FINAL MOTIVATIONAL REPORT

**PART 2 AMENDMENT: AS PART OF THE PROPOSED BOITSHOKO  
SOLAR POWER PLANT NEAR KATHU IN THE NORTHERN CAPE  
PROVINCE**

**DEA Reference No.** : 14/12/16/3/3/2/935/AM3

**Report Status** : Final Motivational Report

Figure 3.1: Proposed amendments

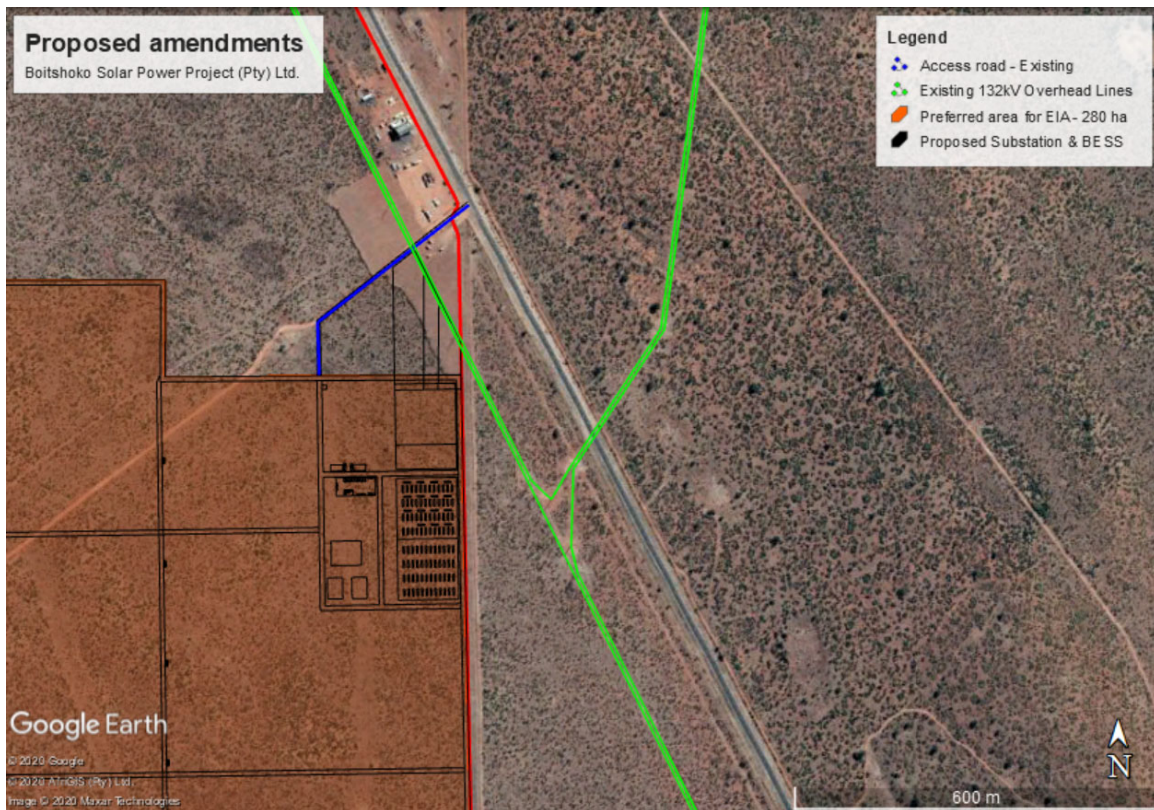
The following amendments are being applied for in terms of the EIA Regulations, 2014 (as amended in 2017)(refer to Figure 3.1):

- Inclusion of a battery storage system

- Increasing capacity of 115MWdc to up to 150MWdc

- Increasing the height of the panels

- Increase of Substation footprint and description to accommodate for IPP Step-up Substation and Switching Station

- Amending the location of inverters, buildings and internal roads within the development footprint (revised layout)

**Figure 3.2:** Corner coordinates of the proposed BESS

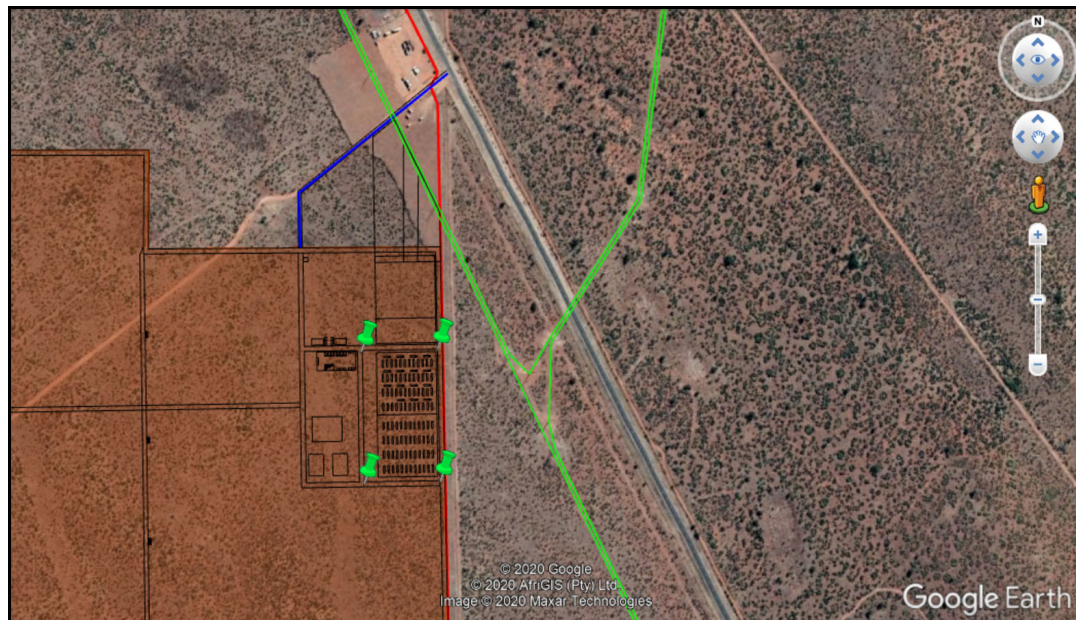
Given the ongoing improvement in battery storage technology and the significant advantages of combining battery storage with renewable generation, it is proposed that battery energy storage systems “BESS” be included for this project in order to meet the requirements to tender the project for the new generation capacity under the Risk Mitigation Independent Power Producer Procurement Program (RMIPPPP) by the Department of Mineral Resources and Energy (DMRE). One of the DMRE’s conditions to tender the project under the RMIPPPP is that all projects must be able to operate between 5h00 and 21h30 in order to supply the grid during peak hours early in the morning and late afternoon when the sun has set, which can only be done by using a battery storage system. The battery storage system will therefore improve the desirability of the proposed project as well as its efficiency.

The capacity of the battery storage facility per project will be kept in standard shipment containers or smaller containers (“blocks”) as might be proposed by selected supplier with an area of approximately 2ha. The battery to be installed will be lithium-ion and no electrolytes will be transported to and handled on site. Battery cells will be assembled at the supplier factory prior to delivery to the sites. The battery storage facility will be located within the already authorized PV plant footprint area (refer to Figure 3.2 for the corner coordinates of the proposed BESS). There will be no need for the additional clearance of more than 2 ha of vegetation for the development of a new area for the battery storage facility.

**Figure 3.3:** Substation and switching station (figure for illustration purposes only)

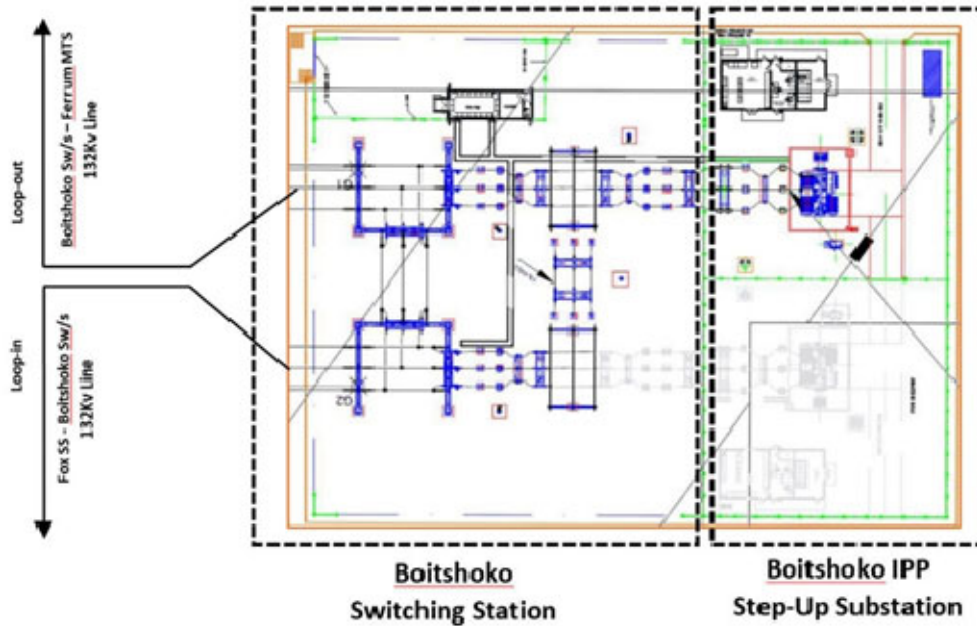
The proposed on site substation will have a combined footprint of approximately 1.4ha and will consist of an IPP Step-up substation and a Switching Station. The Boitshoko step-up substation will step-up the generated capacity to 132Kv in order to connect and supply at the same Voltage as the existing grid. The Switching Station will be the connection between the Step-up Substation and the Existing Ferrum – Fox 132Kv Line (refer to figure 3.4 for an illustration of the substation infrastructure).
